RHODE ISLAND CONTRACT No. 2017-CB-053

Rehabilitation of Silver Creek Bridge No. 153

NOTICE TO PROSPECTIVE BIDDERS

ADDENDUM NO. 2 Prospective bidders and all concerned are hereby notified of the following changes in the Plans, Specifications, Proposal and Distribution of Quantities for this contract. These changes shall be incorporated in the Plans, Specifications, Proposal and Distribution of Quantities, and shall become an integral part of the Contract Documents.

DRAINAGE AND UTILITY PLAN

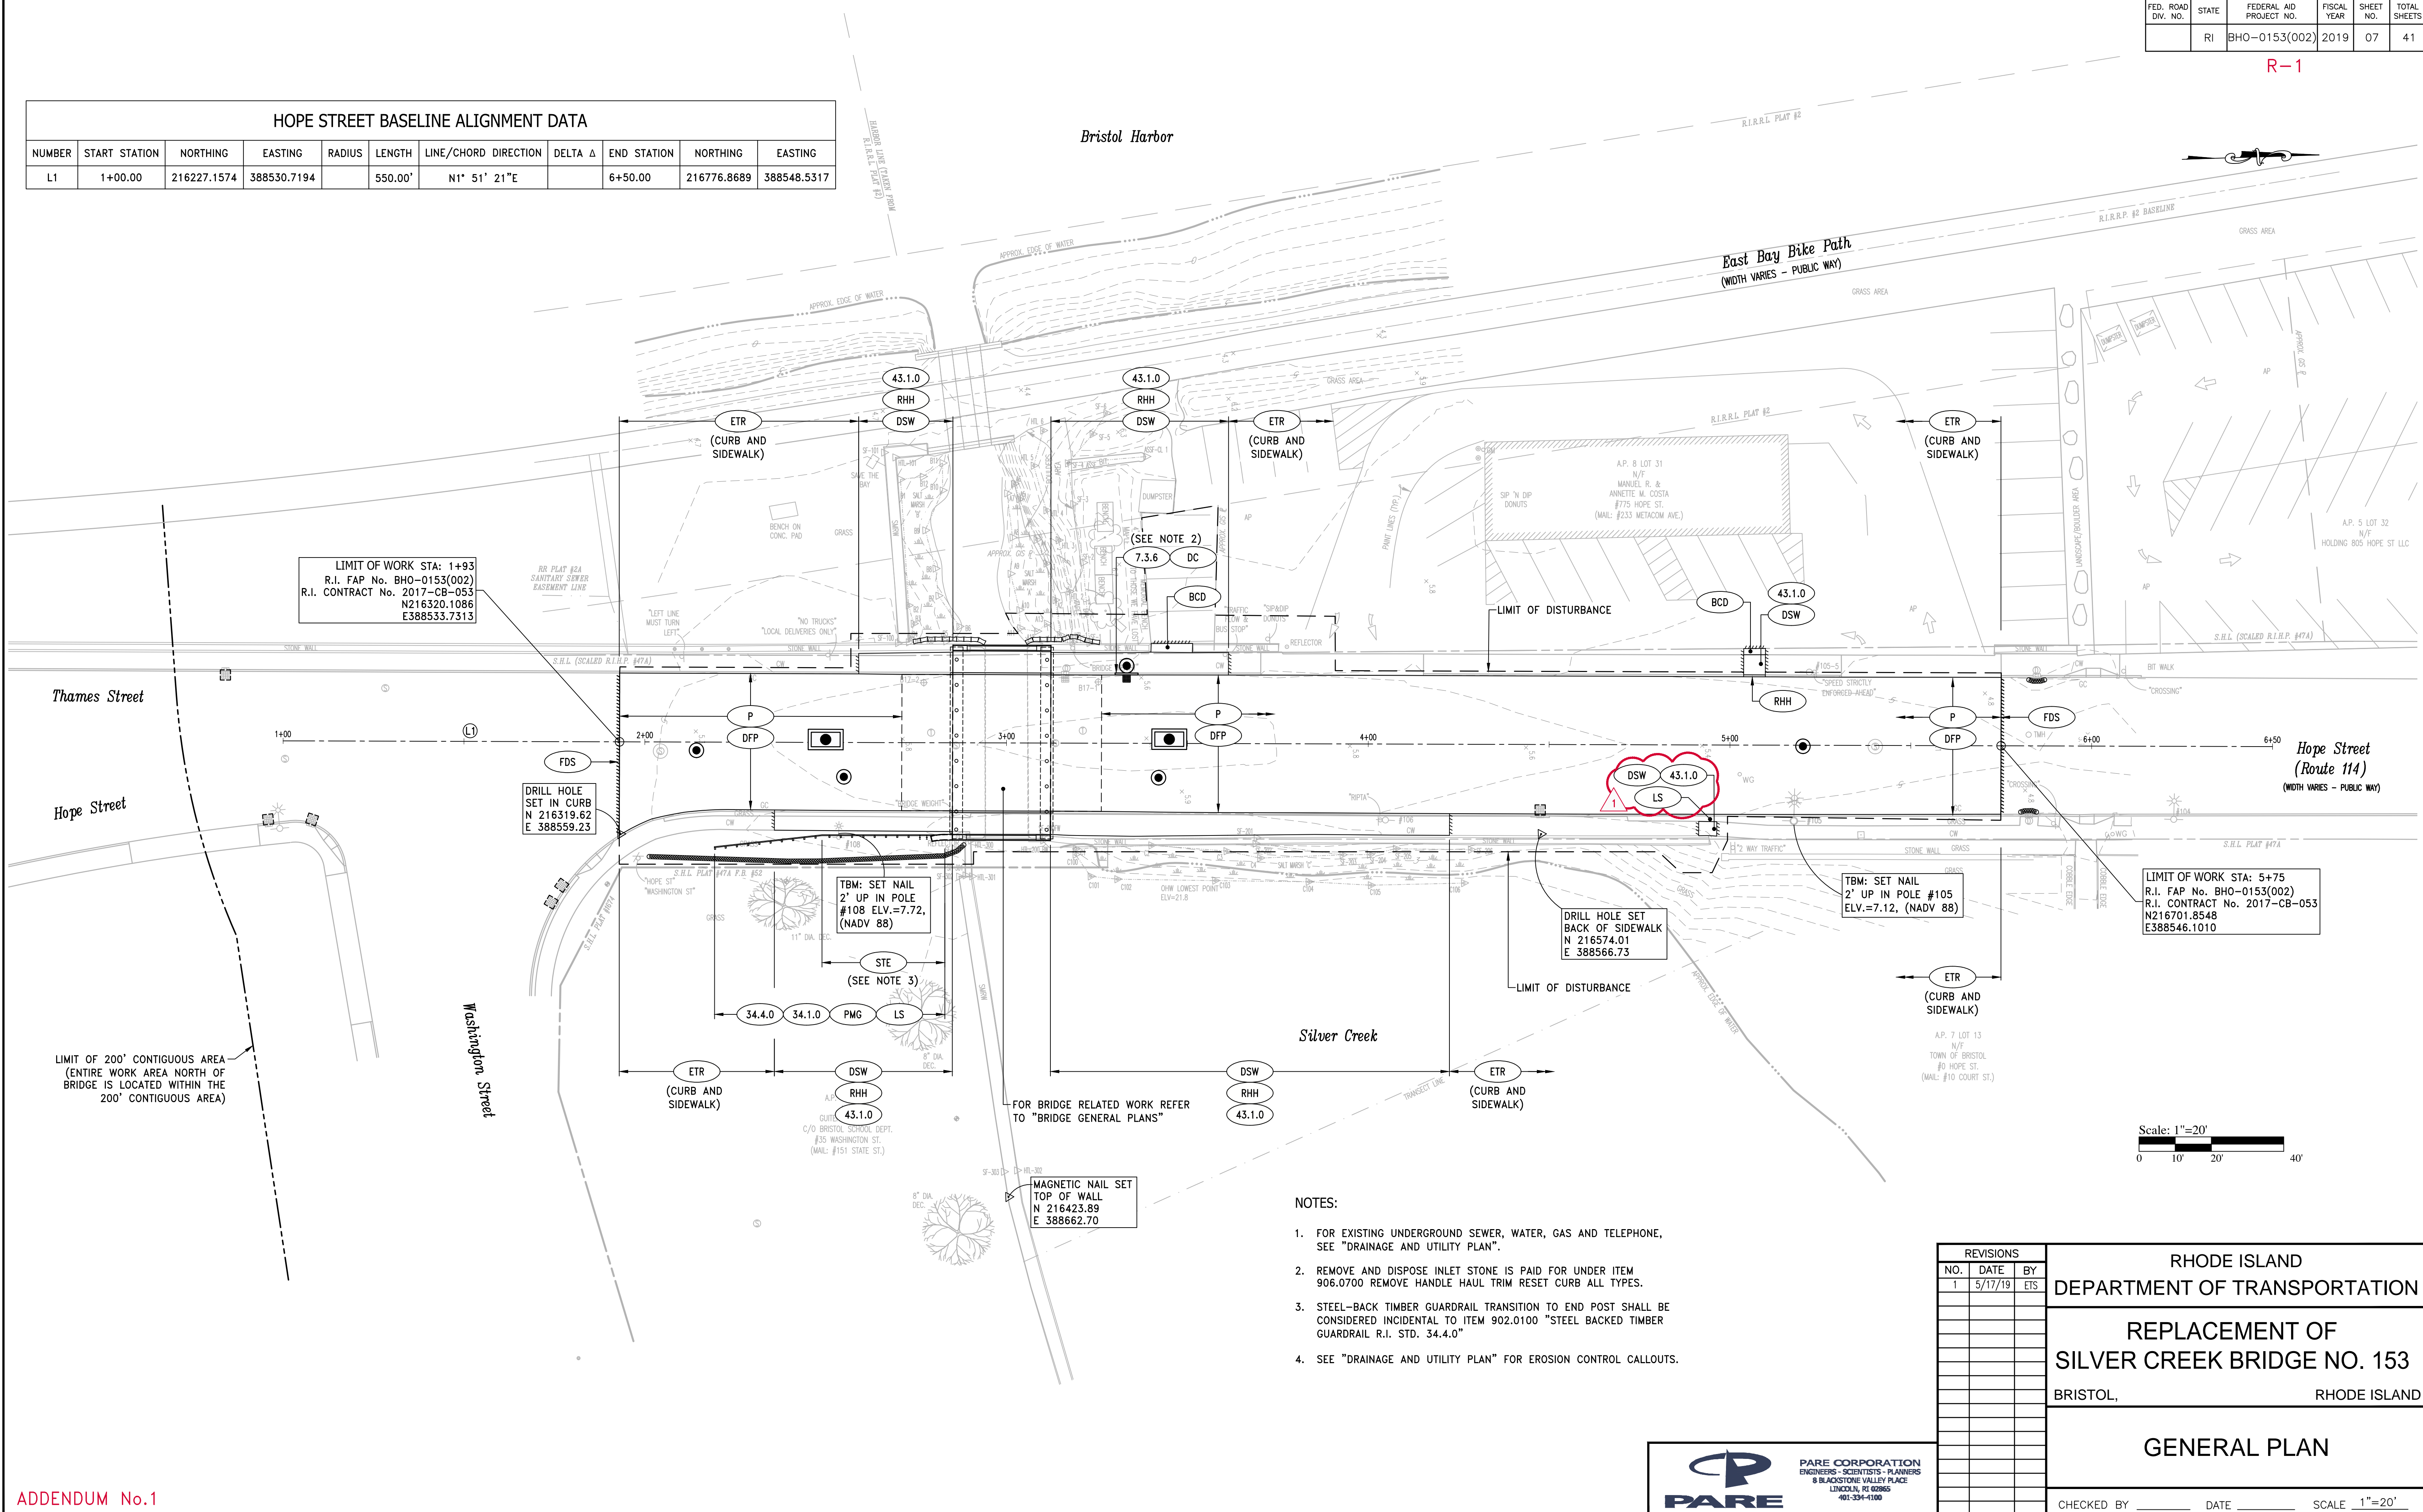
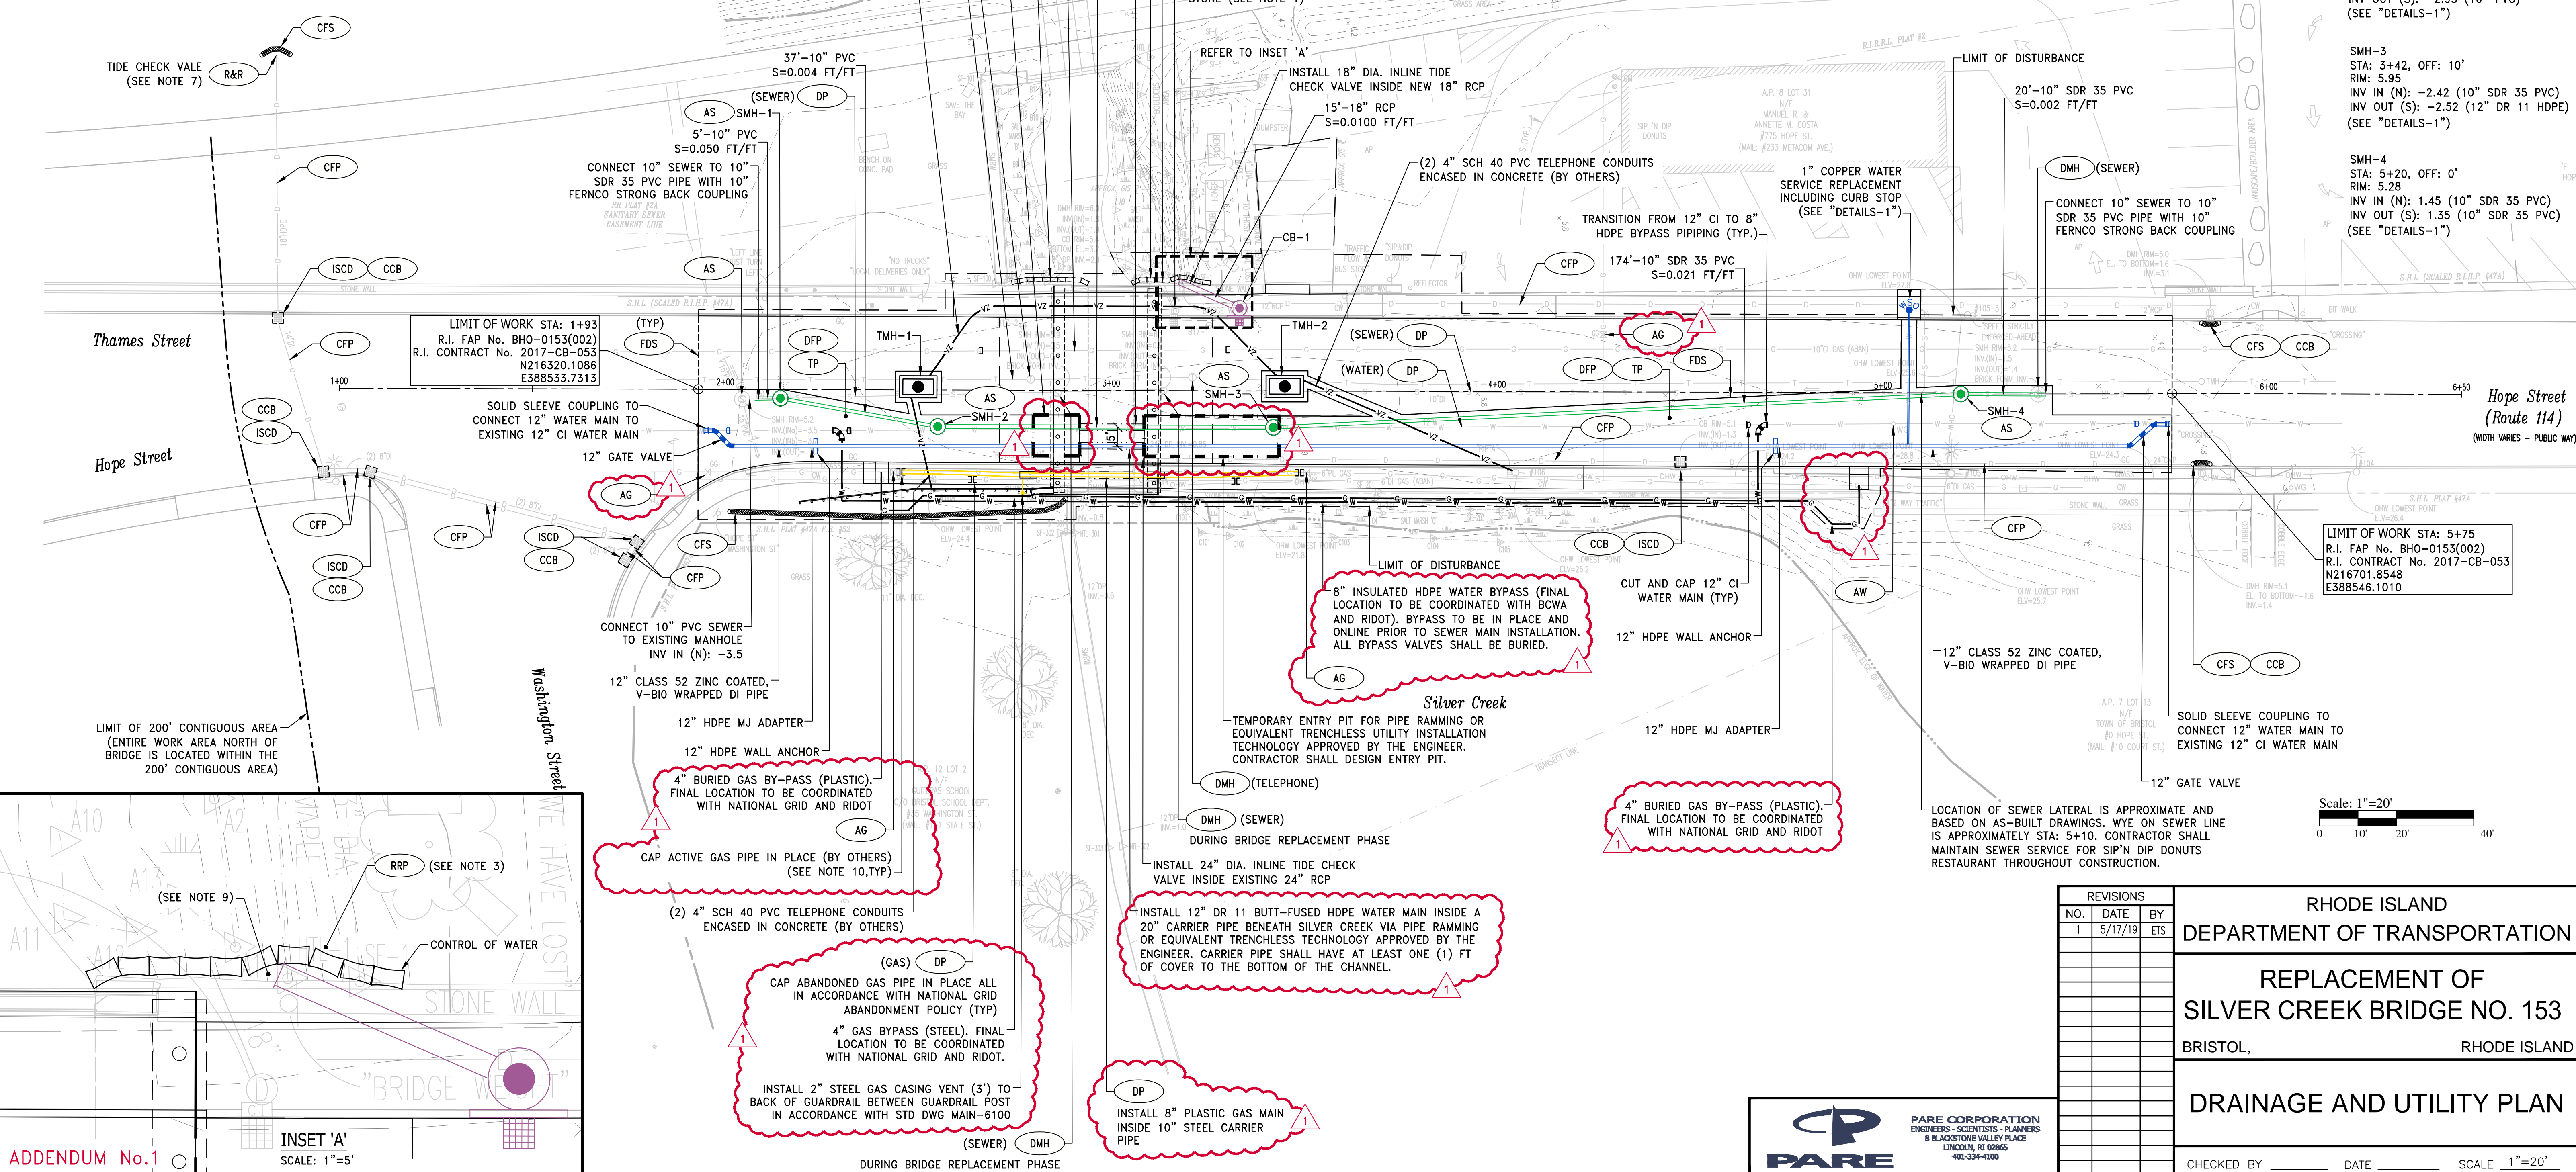
4. Replace Plan Sheet 8 with Sheet 8(R-1) attached to this Addendum #2.
The following water and sewer information have revised:
The anticipated temporary pit locations for the jacking of the water and sewer have been moved directly behind the existing abutment walls.
The water bypass pipe has been changed to 8" Insulated HDPE.
The following gas line information have been revised:
The gas main casing has been changed to 10"
Gas gates have been called to be adjusted to grade
The layout of the gas bypass has been revised to 4" Steel over the channel crossing and 4" plastic buried pipe elsewhere.
A 2-inch steel casing vent is to be installed to the back of the guardrail in between the posts.
National Grid will be responsible to cap active gas pipe in place. Contractor is responsible to remove the pipe in the vicinity of the casing.

SEWER MAIN AND WATER
MAIN PROFILES

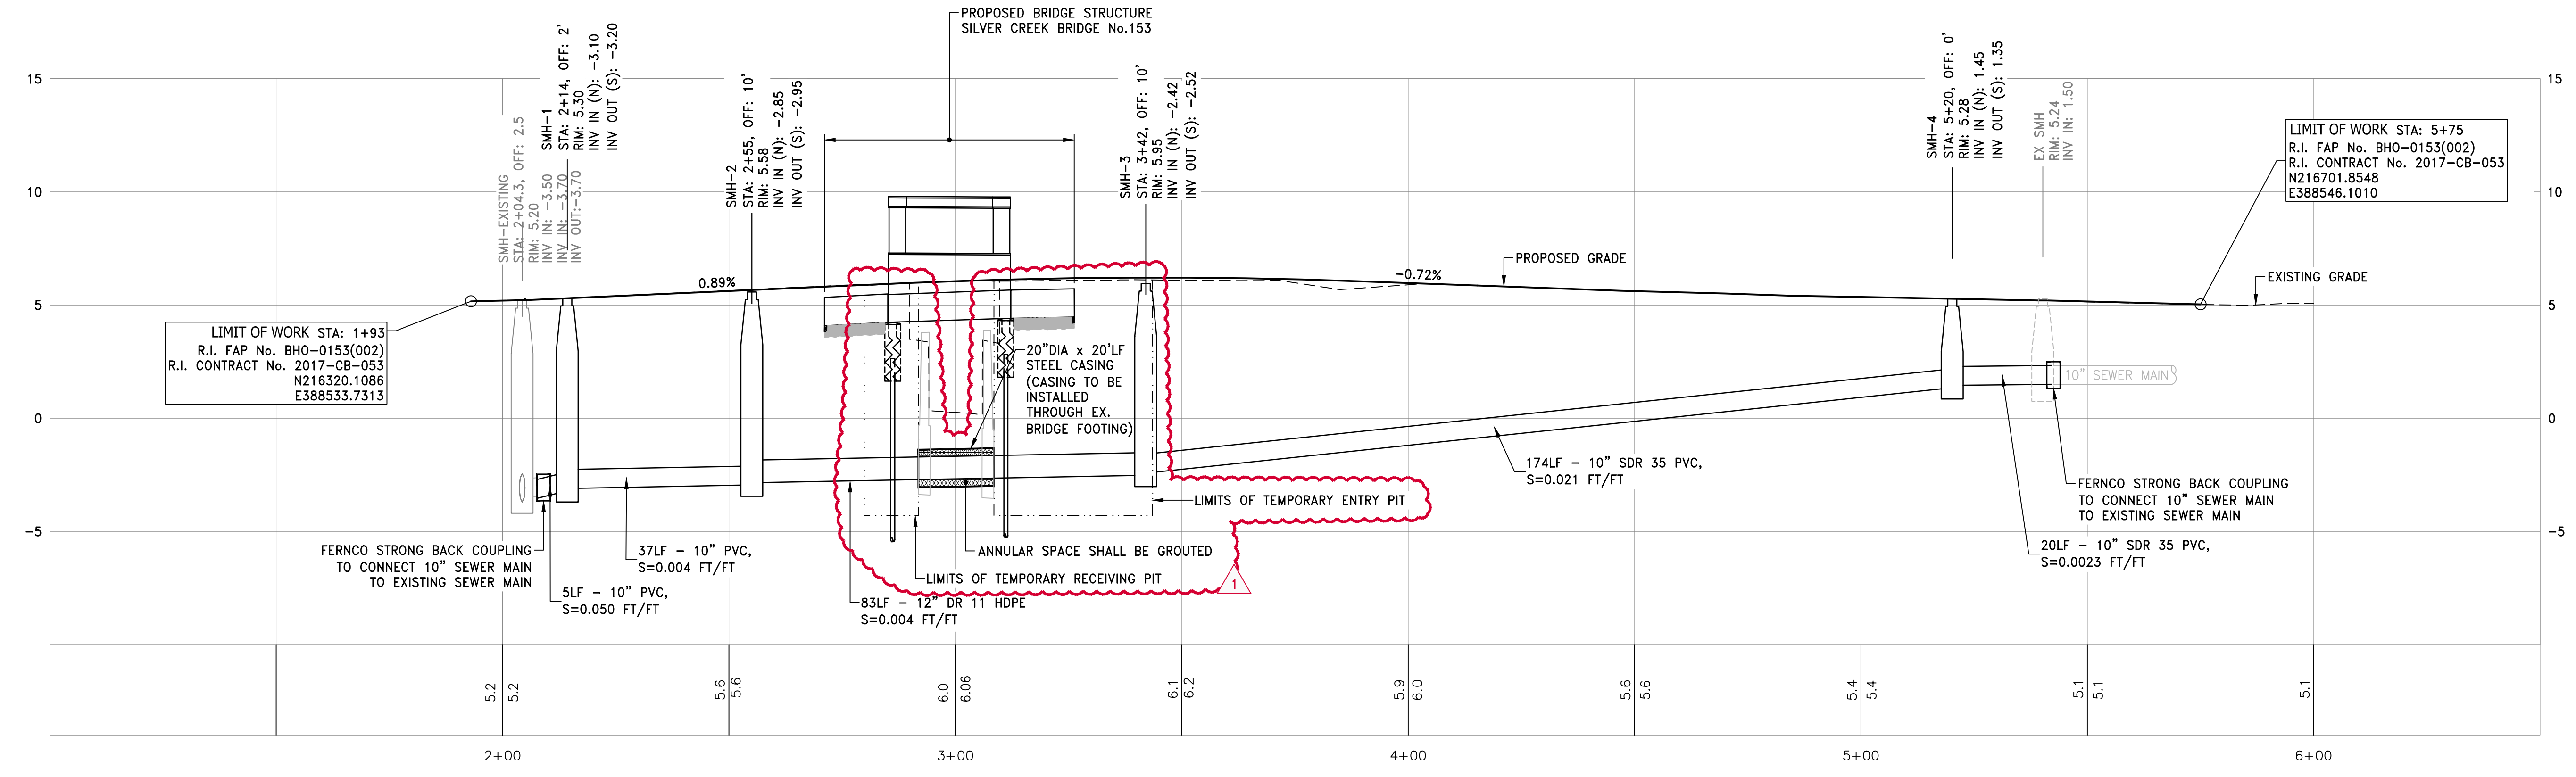
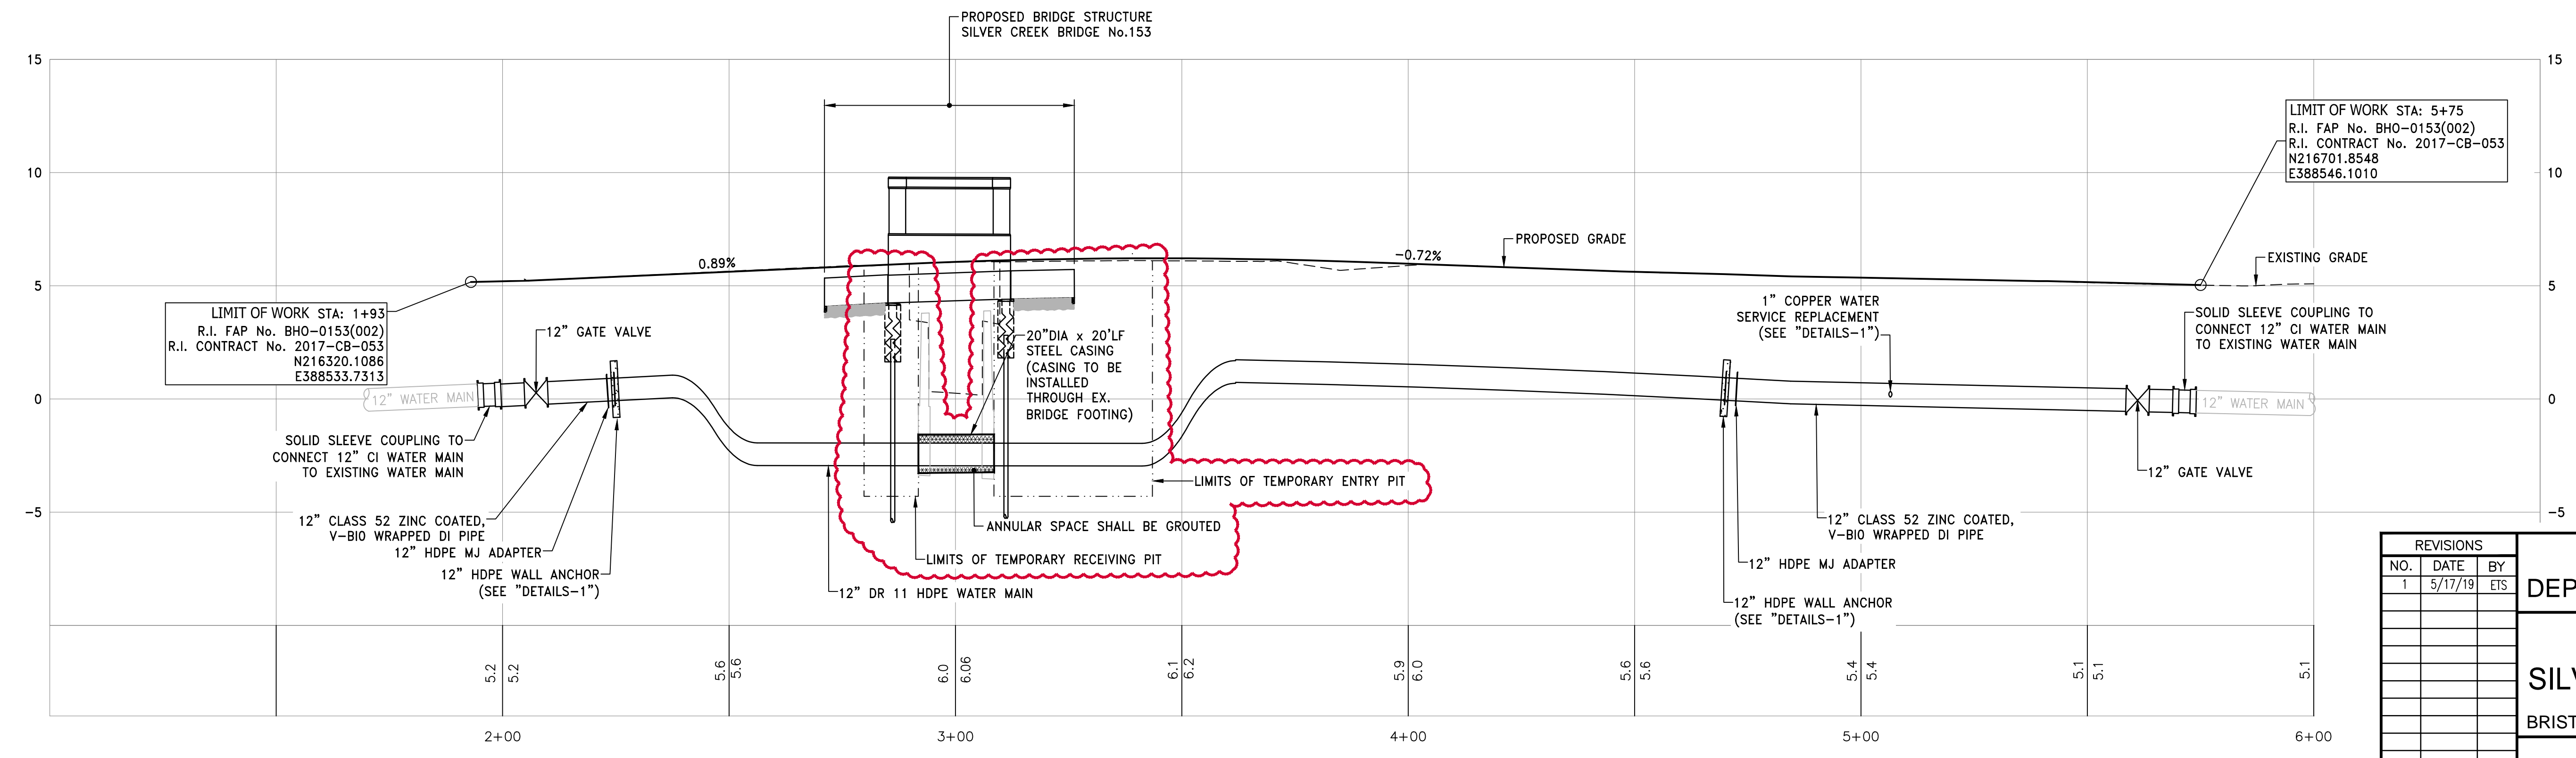
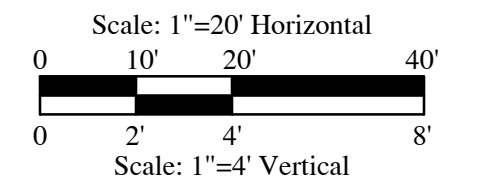
NOTE:
SEE "EXISTING CONCRETE FOOTING REMOVAL LIMITS" DETAIL ON "MISCELLANEOUS DETAILS" SHEET FOR LIMITS OF THE FOOTING REMOVAL FOR PLACEMENT OF CASINGS.
